**LIST OF SPECIAL INSPECTIONS**  
**WASP R985-AN5, -14B ENGINES**

(This EO replaces EO 10A-10AA-5 dated 16 Jan 62)

**CHECK TO ENSURE THAT A SURPLUS GASKET  
36P/39577 IS NOT INSTALLED AND THAT  
PIPE ASSEMBLY 36P/39580  
IS IN SERVICEABLE CONDITION**

(This EO replaces EO 10A-10AA-5/6 dated 10 Nov 61)

Figure 1

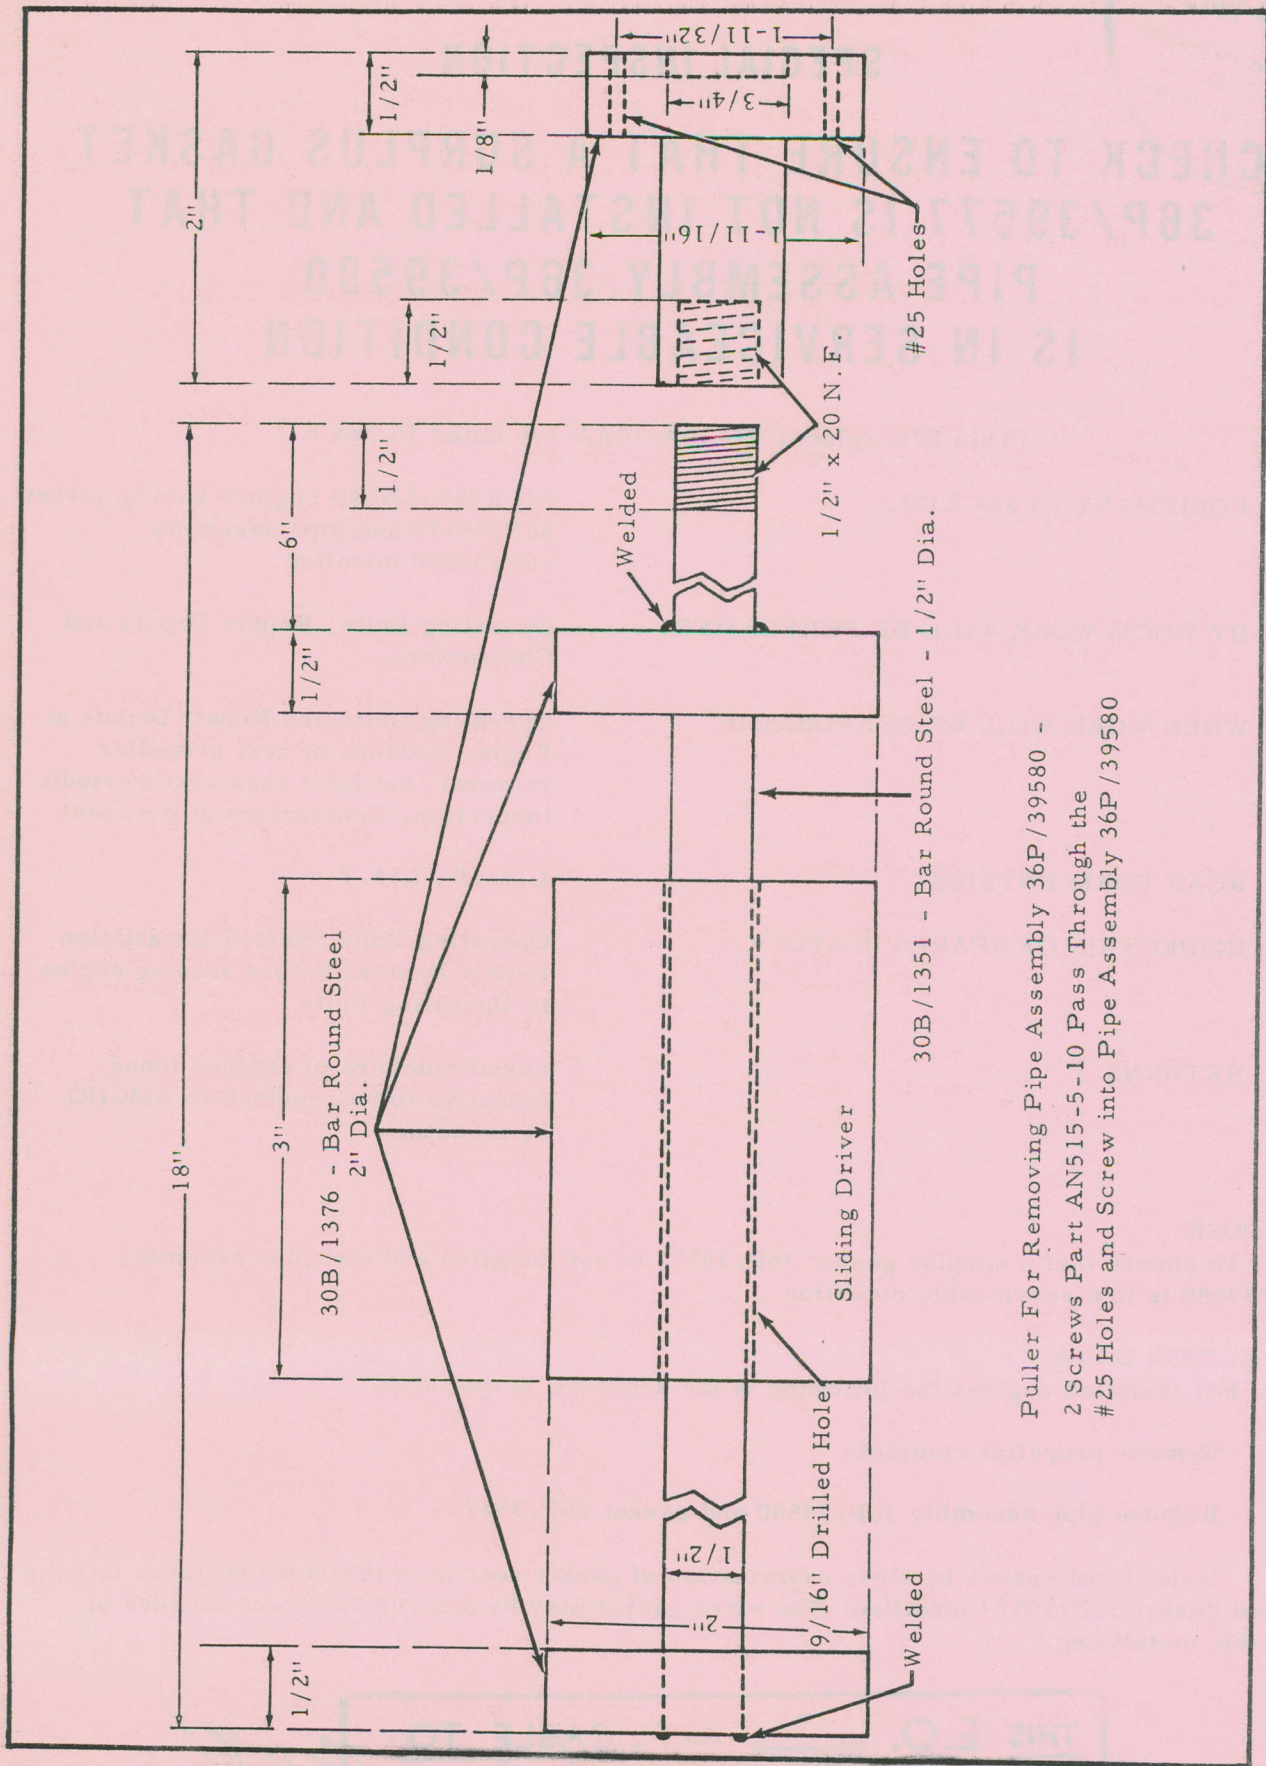
- (a) It is estimated that approximately one man-hour per engine will be required. Pipe assembly can be removed using wrench 36P/PWA2713 and puller manufactured locally as per Figure 1.

Figure 1 (Issue 1)

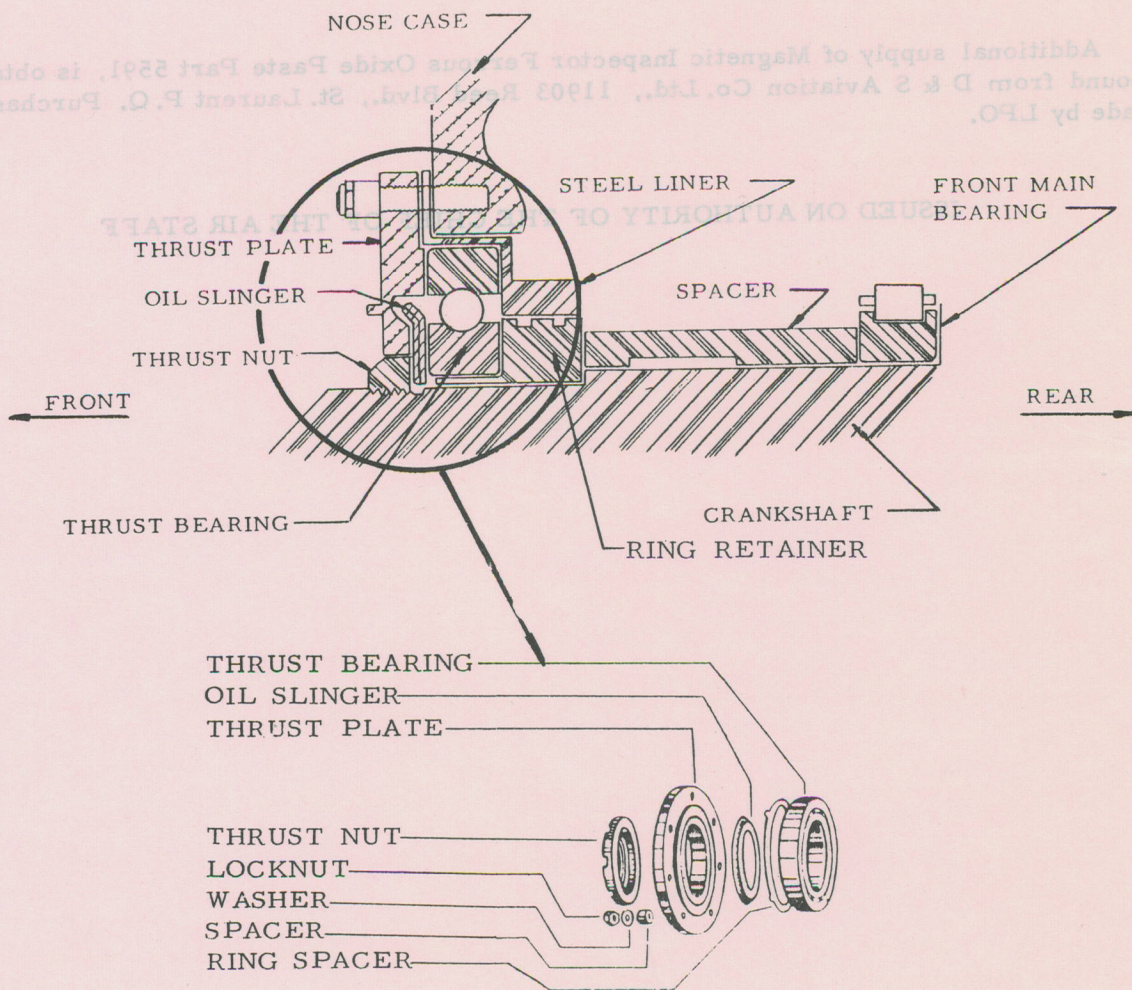
- (c) The following description and reference to Figure 1 will clarify and provide an explanation for these conditions.
- (1) When the thrust nut is locked in position it bears against the inner race of the thrust bearing, the ring retainer, the spacer, then the inner race of the front main bearing, which is then locked against the cheek of the crankshaft causing the whole assembly to turn with the crankshaft. Conversely when the thrust nut is removed, as the ring retainer, which the inner race of the thrust bearing is seated on, has a permissible clearance of .0025" to .004" between the crankshaft, it may not turn when the crankshaft is rotated.

- (2) The outer race of the thrust bearing is only locked in the nose section steel liner when the thrust plate is in position, and torqued. This bearing also has a maximum clearance of .004" between the OD of the race and the steel liner.

- (d) Ensure that the thrust nut is torqued to the prescribed requirements, i. e. using tool PWA 1093 modified to RCAF Drawing 21938 for adaption of torque wrenches 360 ft lbs or 3600 inch lbs with 3/4" drive, torque to 250 ft lbs and further tighten through 25 to 30 degrees.
